Addendum No. 01

Subject: **R. Morris Classroom Modernization Project
B-043C, B-044C of 2018/19**

Location: **Robert Morris School
2600 W. Thompson Street
Philadelphia, PA 19121**

This Addendum, dated February 28, 2019, shall modify and become part of the Contract Documents for the work of this project. Any items not mentioned herein, or affected by, shall be performed strictly in accordance with the original documents.

DRAWING NO.
D1.1

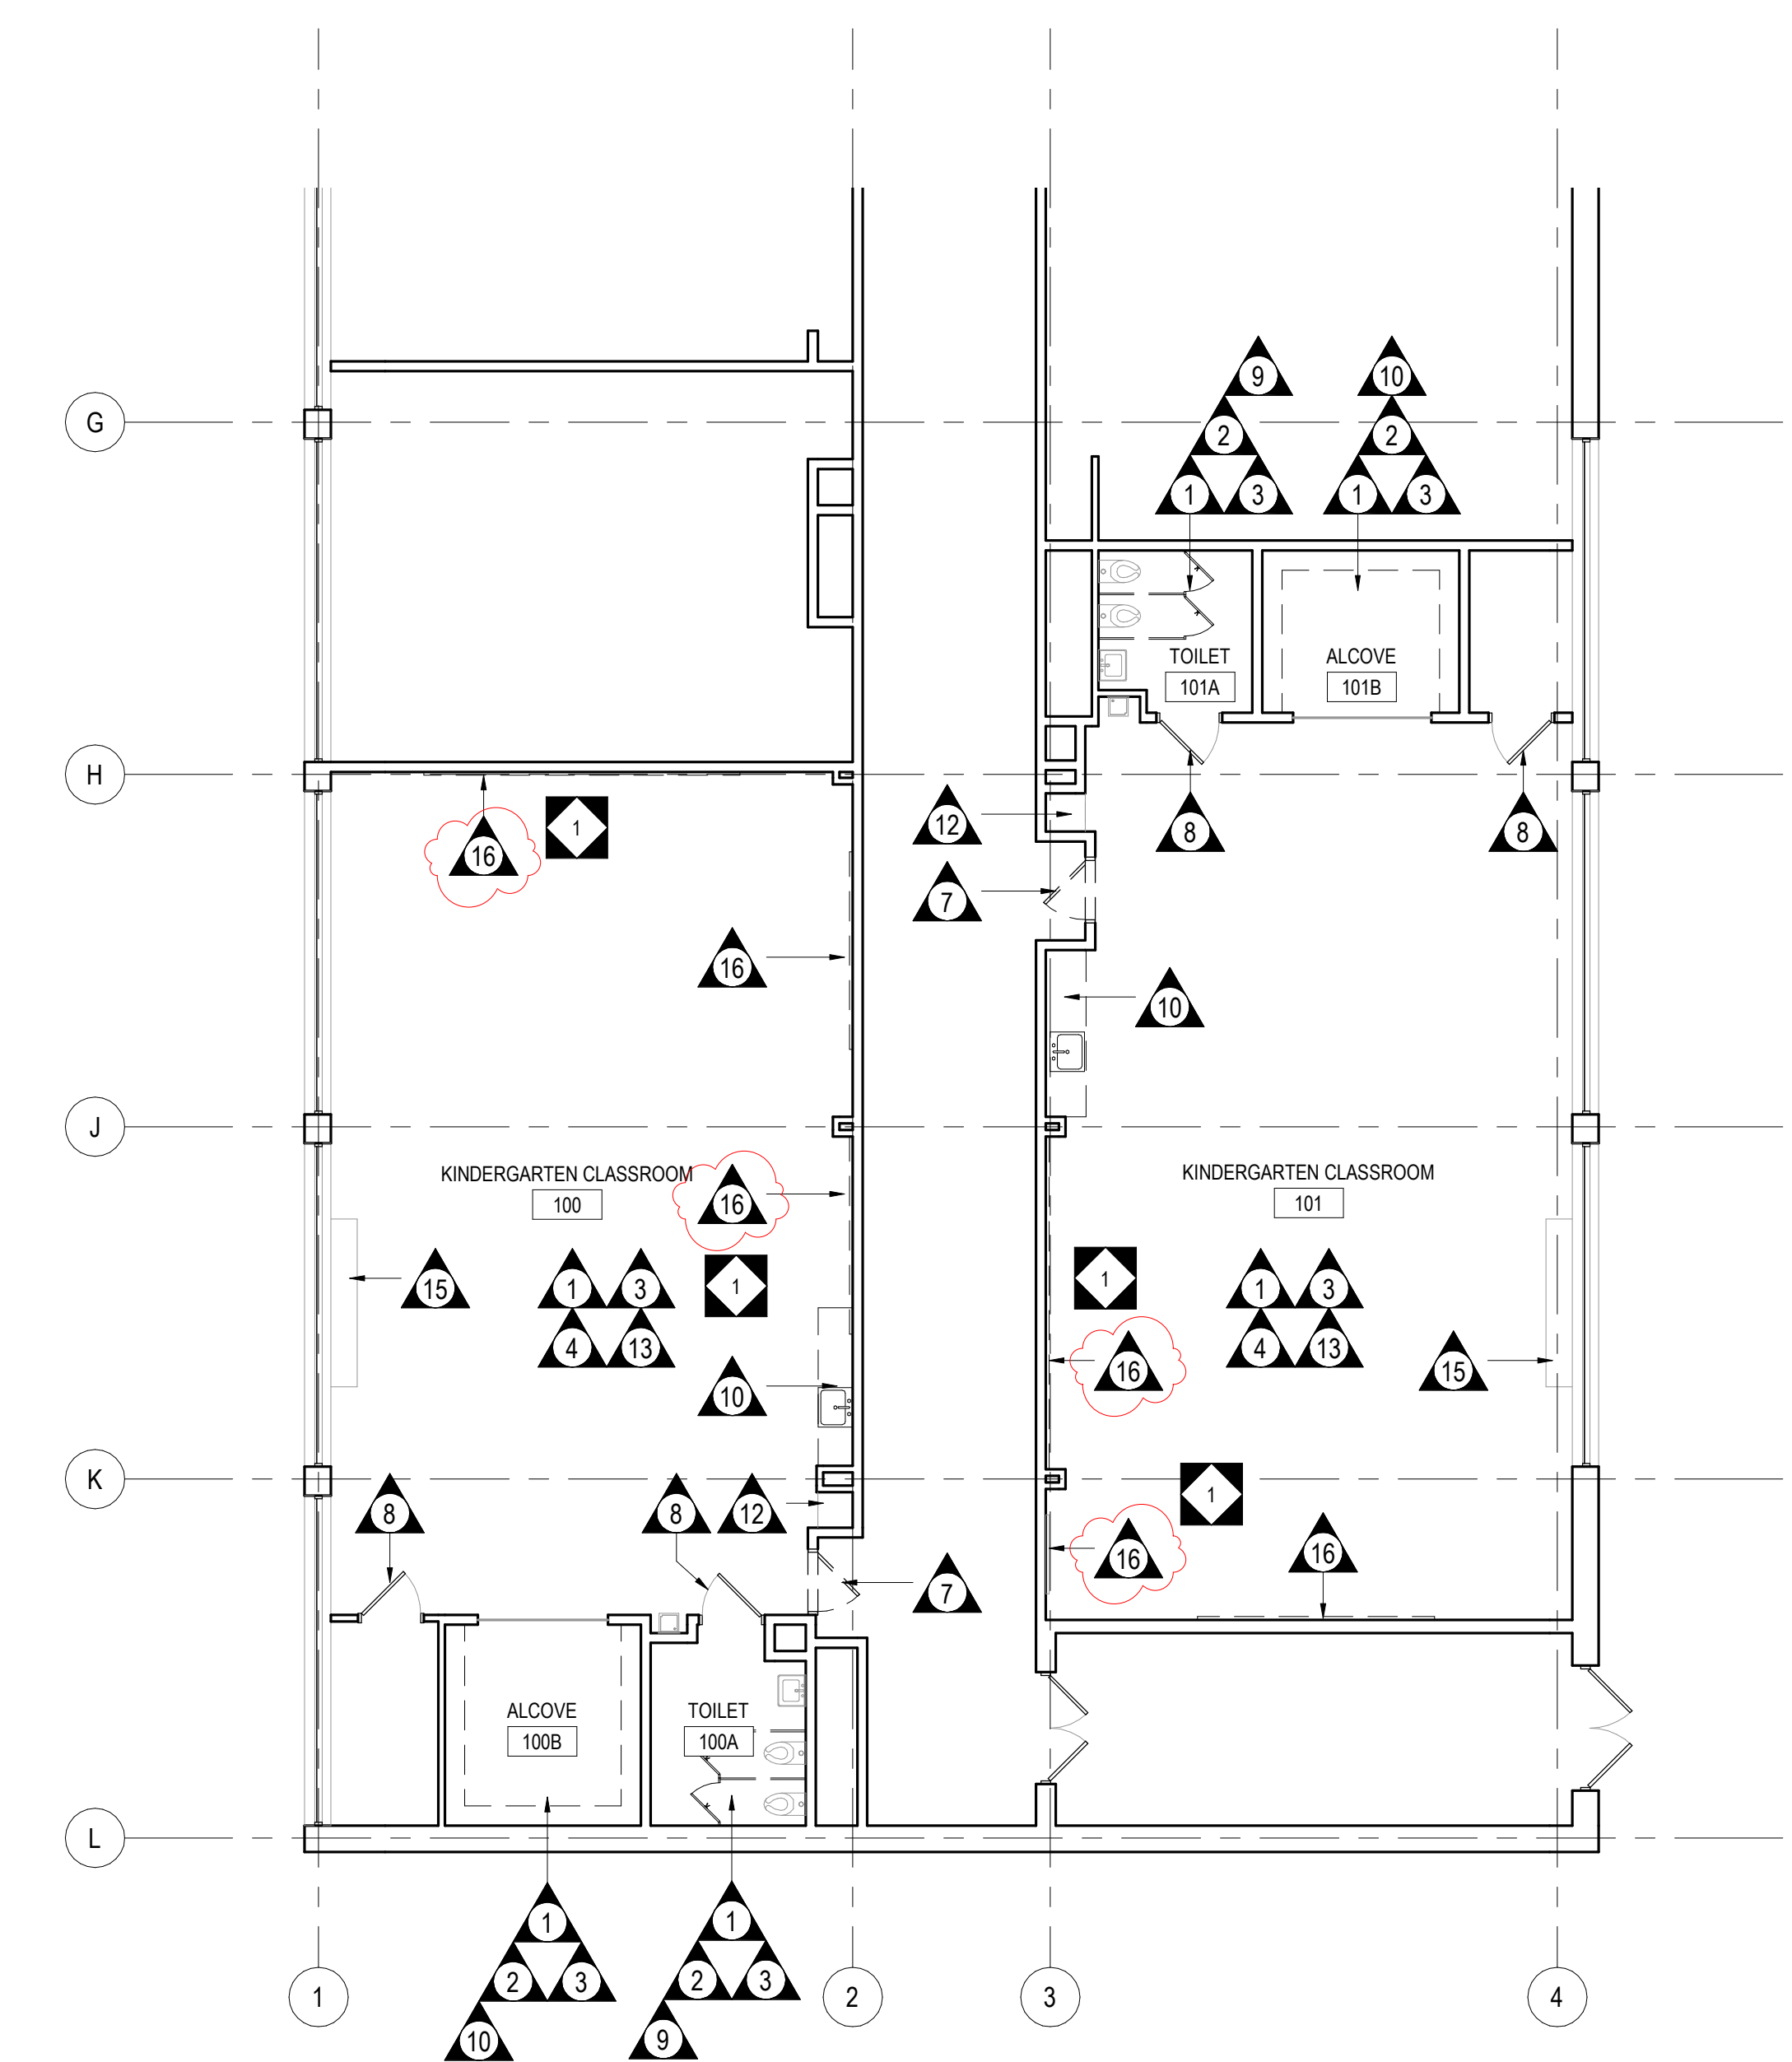
9. Question: Reference Morris School drawings D1.1-D1.2 NOTE 14 indicates prepare board for new infill (no demo). Drawings 14.1-14.2 elevations and schedules indicate SDP supplied boards @ these locations. Please confirm which is correct leave existing boards in place & infill per spec. or demo existing boards and install SDP supplied boards.

Response: Revised Drawing D1.1 and D1.2 to remove note #14 in its entirety and revised to read Note #16. Refer to attached drawings.

16	REMOVE EXISTING DISPLAY BOARD, TRIM AND ALL RELATED COMPONENTS. PATCH AND REPAIR ADJACENT FINISHES TO MATCH EXISTING.

G WALL CABINET & COAT HOOK LAYOUT - TYPICAL
14.3 1/4" = 1'-0"

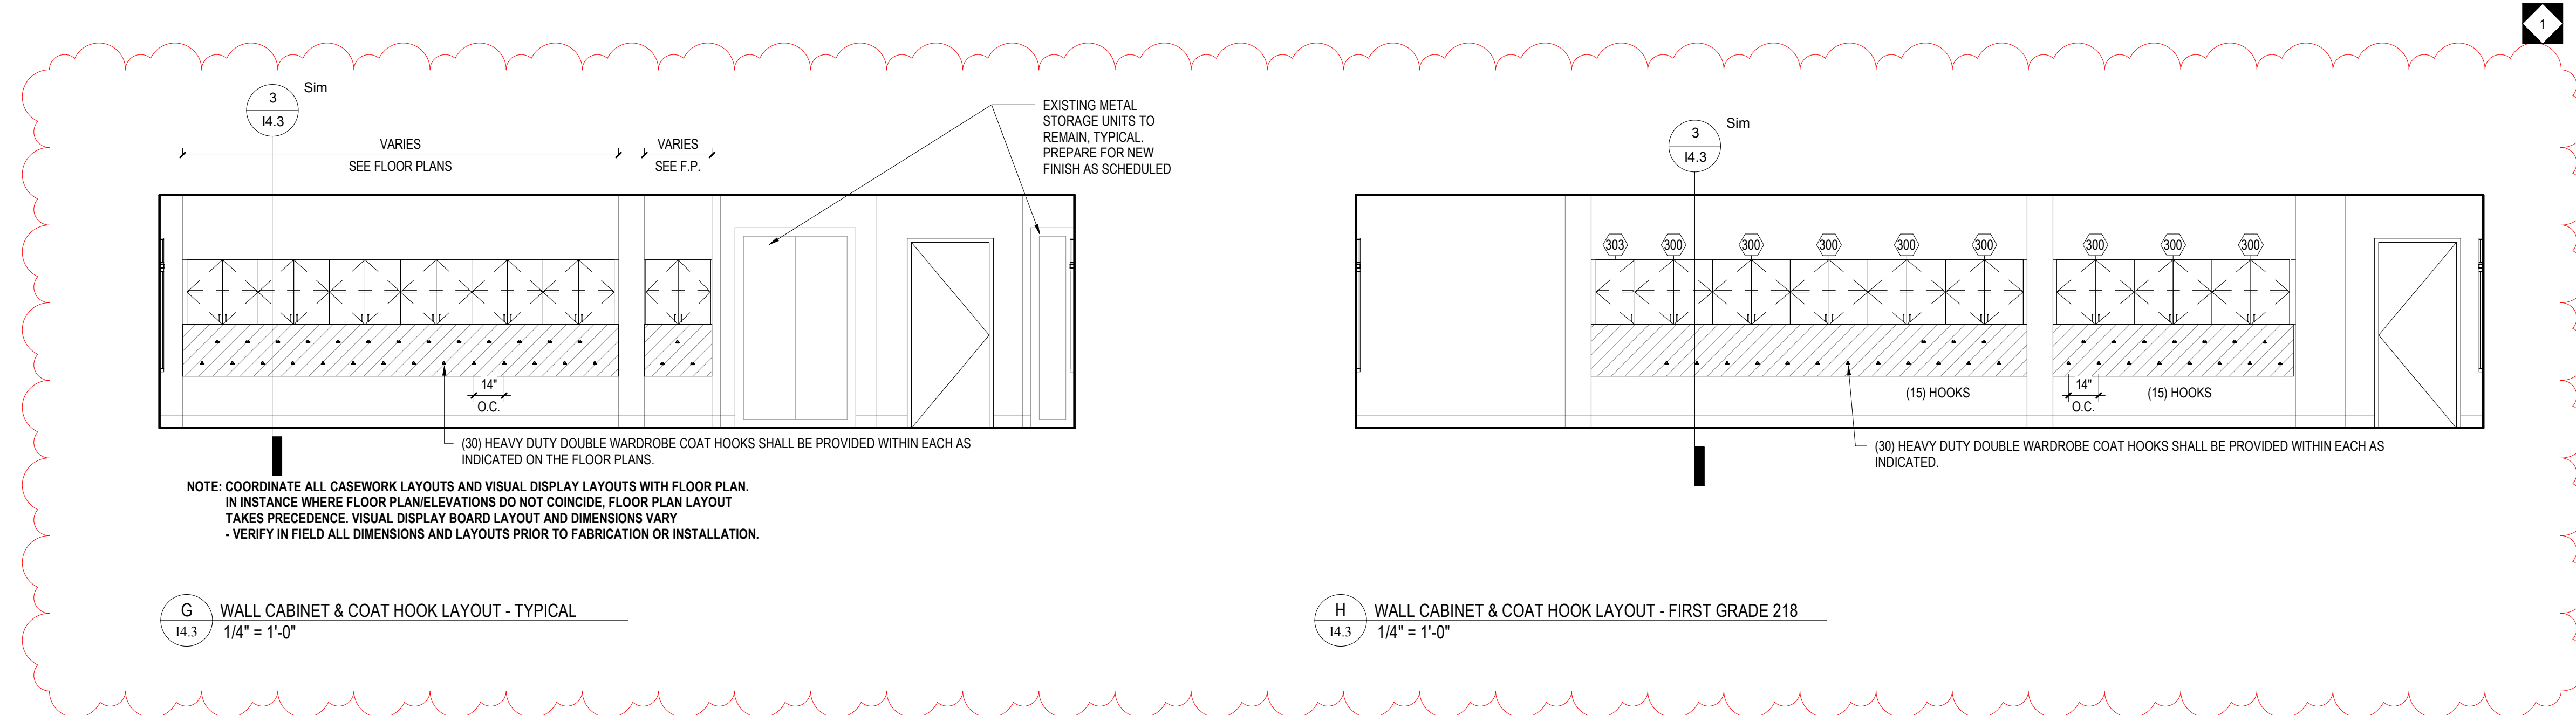
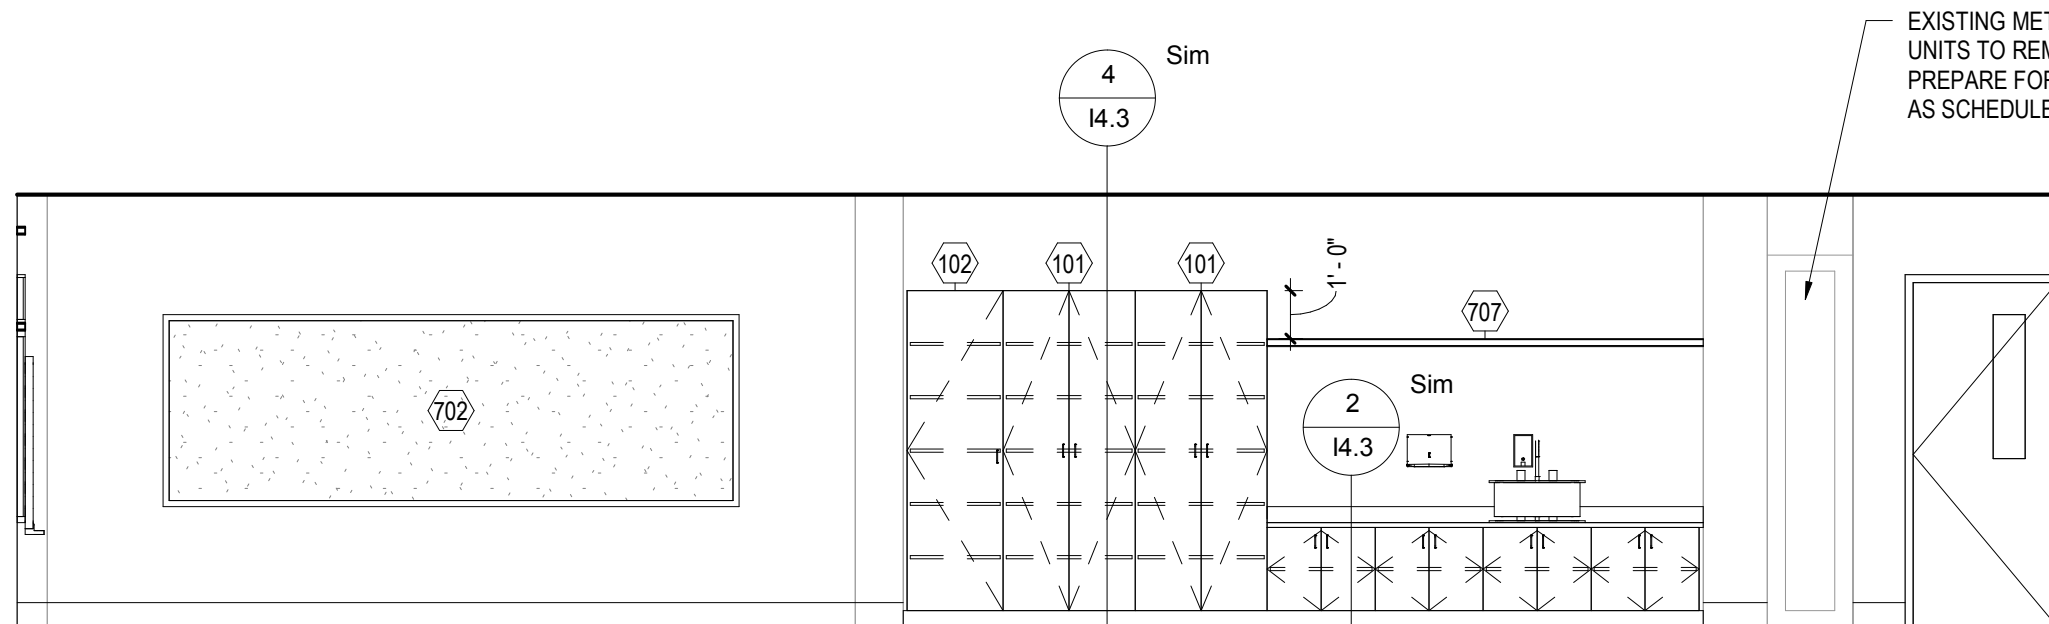
- a. Toilet Accessory Schedule on drawing I4.1 has been revised. Refer to attached drawing.
- b. Details G/I4.3, H/I4.3 and 3/I4.3 have been revised. Refer to attached drawing.

1 ELECTRICAL OVERALL SECOND FLOOR PLAN - DEMOLITION WORK
ED1.2 1/8" = 1'-0"

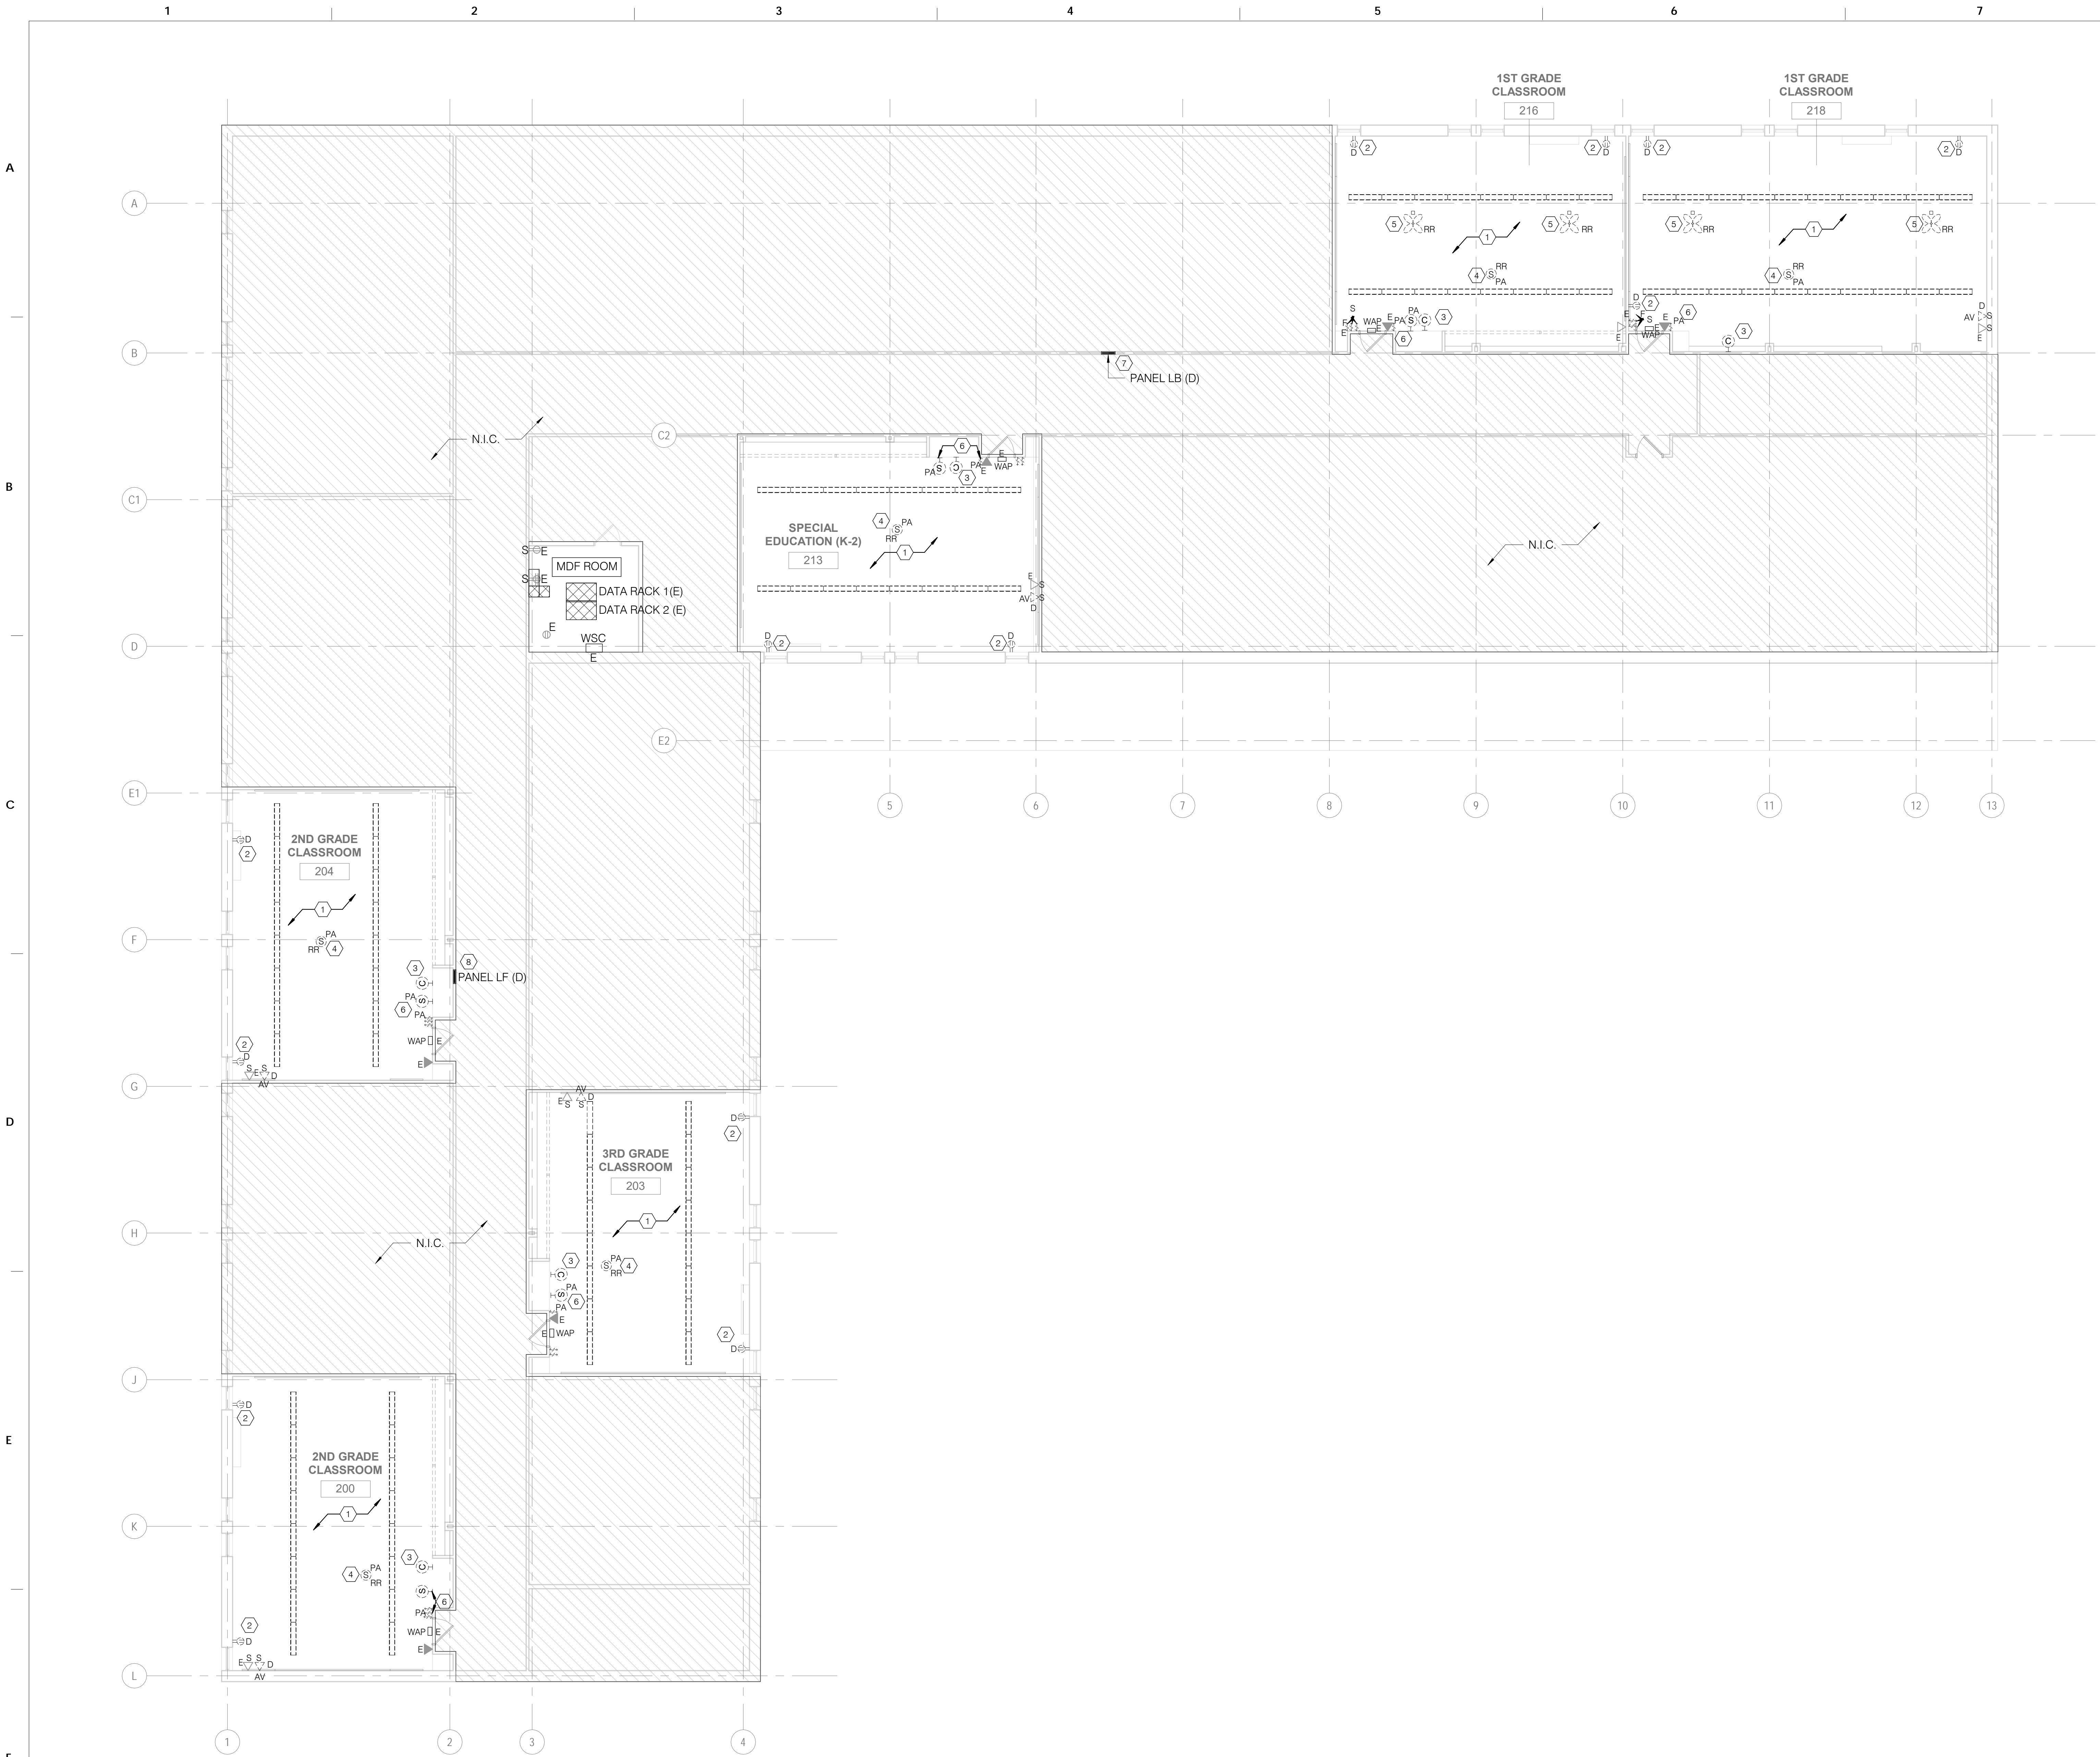
11. Question: Drawing ED.1: Do we remove and re-install ceiling fans in Rooms 216 and 218? Note on drawing states to blank off clock.

Response: All existing ceiling-mounted circulation fans are to be removed and reinstalled in place to accommodate new ceiling. Contractor to field test functionality and replace switch if required. Refer to revised Note 5 on Sheet ED1.2.

- ALL EXISTING CEILING MOUNTED CIRCULATION FANS TO BE REMOVED AND REINSTALLED IN PLACE TO ACCOMMODATE NEW CEILING. CONTRACTOR TO FIELD TEST FUNCTIONALITY AND REPLACE THE ASSOCIATED SWITCH IF REQUIRED. REFER TO NEW WORK PLAN FOR ADDITIONAL INFORMATION.
